111976 - 00

Change Notification #: 111976 - 00
Change Title: Intel® Server Board S2600CP Product Family
PCN 111976-00, Product Design, Transport Media
Update Transport Media and BIOS/BMC/FRUSDR
Date of Publication: December 19, 2012

The following changes are being made to the Intel® Server Board S2600CP Family OEM 10-pack package material:

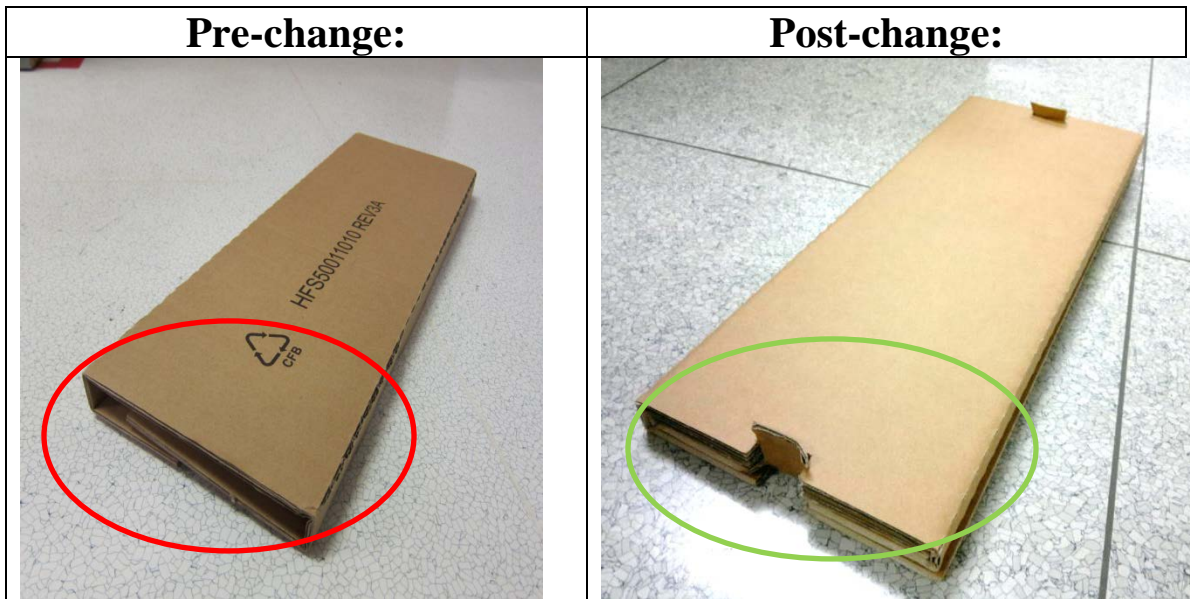
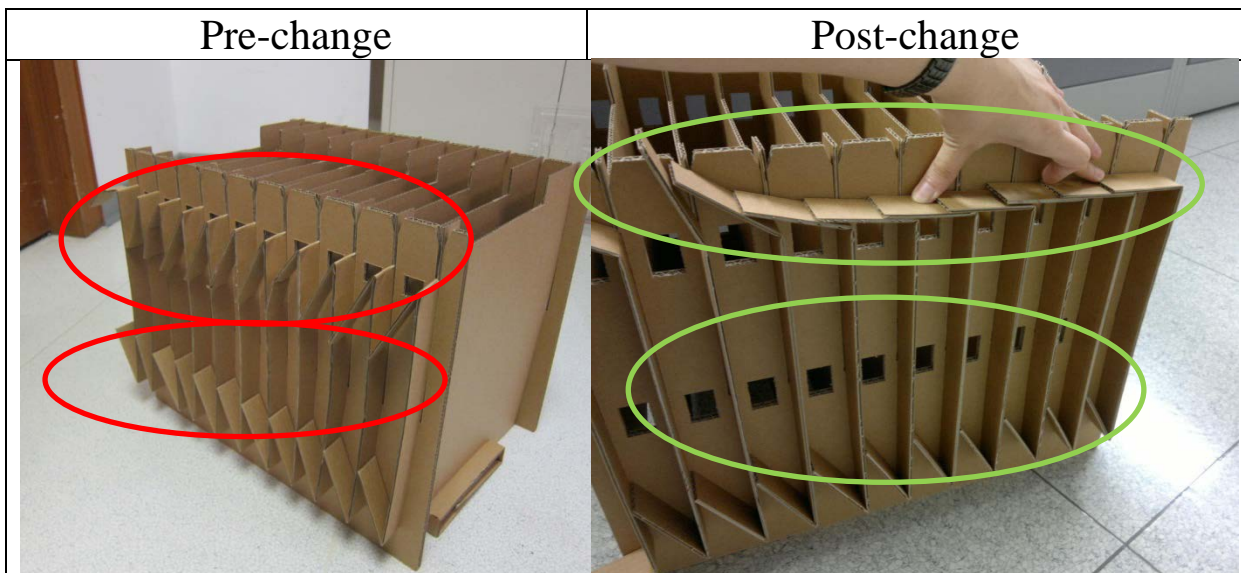
1. Make the paper strip 30mm wider to increase packaging strength to protect the video connector and improve support for the server board. The following is a picture that shows where this strip goes in the package box:

The following are pictures of the pre and post change of the strip:
